FREDERICK COUNTY PLANNING COMMISSION

TITLE: Harmony Hollow, Section 3, Lot 301

FILE NUMBER: S-1109, AP 13910 (APFO N/A, FRO 13912)

REQUEST: Combined Preliminary/Final Plat Approval

Combined Preliminary/Final Plat

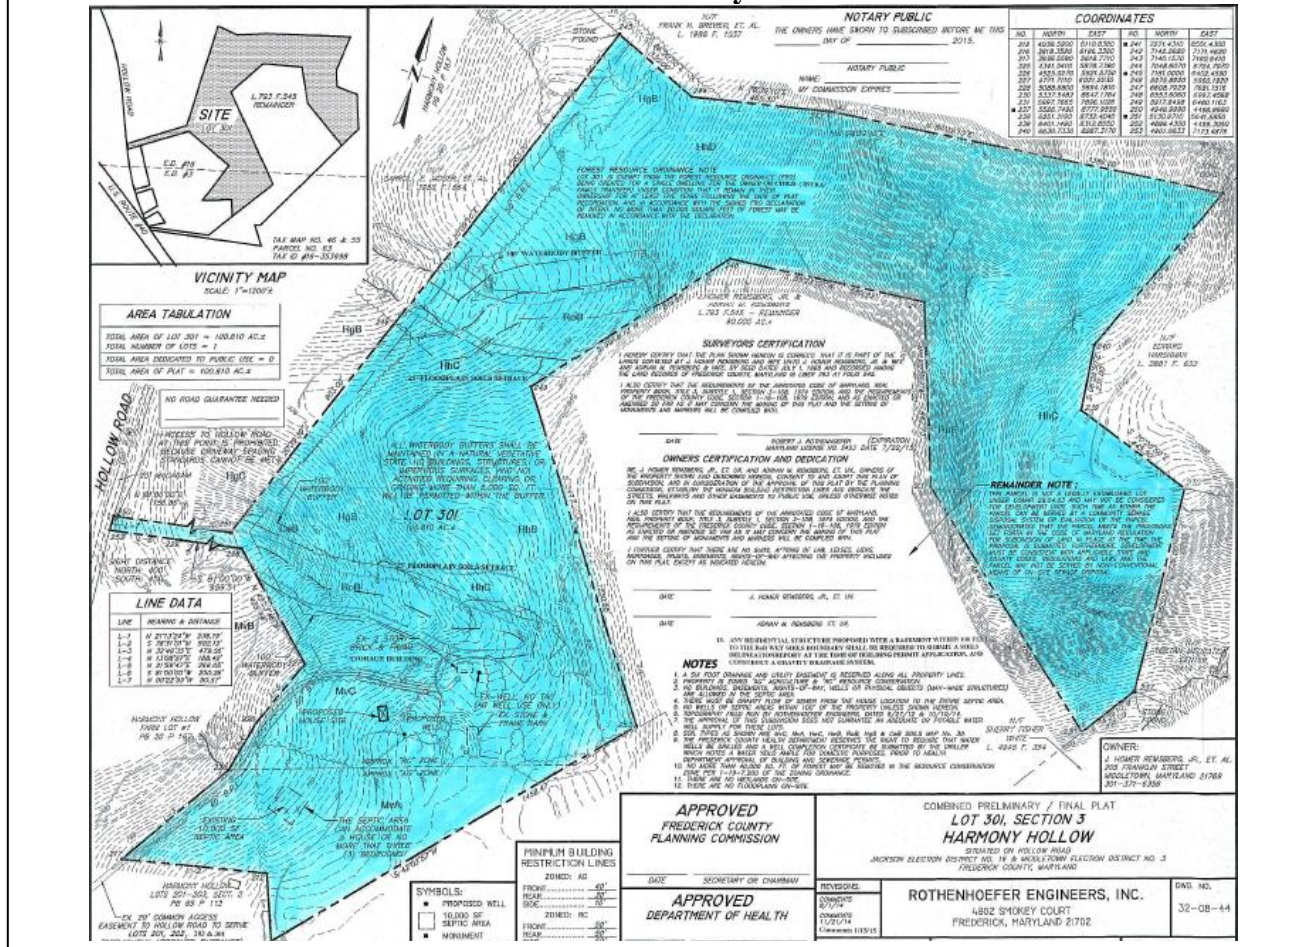
Two streams are located on proposed Lot 301. The application currently depicts a 100 foot waterbody buffer. This appears to be appropriate for the northern most stream channel. The stream located directly behind the abandoned 2 story brick and frame house that has been converted into a storage building is within an area of moderate slope, which requires a 125 foot waterbody buffer. Increasing this waterbody buffer to 125 feet will not impact the lot design or the proposed new house site.

The site contains RoB wet soils, but this soil type is over 300 feet away from the proposed house site. Since the house site will be greater than 100 feet away a soils delineation report is not required.

1. The Applicant shall comply with all Staff and agency comments through the completion of the plan.
2. The Combined Preliminary/Final Plat approval is valid for three (3) years from the date of FcPc approval. Therefore, the Plat approval expires on February 18, 2018.
3. The Applicant shall provide verification from the Maryland Department of Natural Resources that the site does not contain habitats of threatened or endangered species.
4. Increase the waterbody buffer around the lower stream to 125 feet.
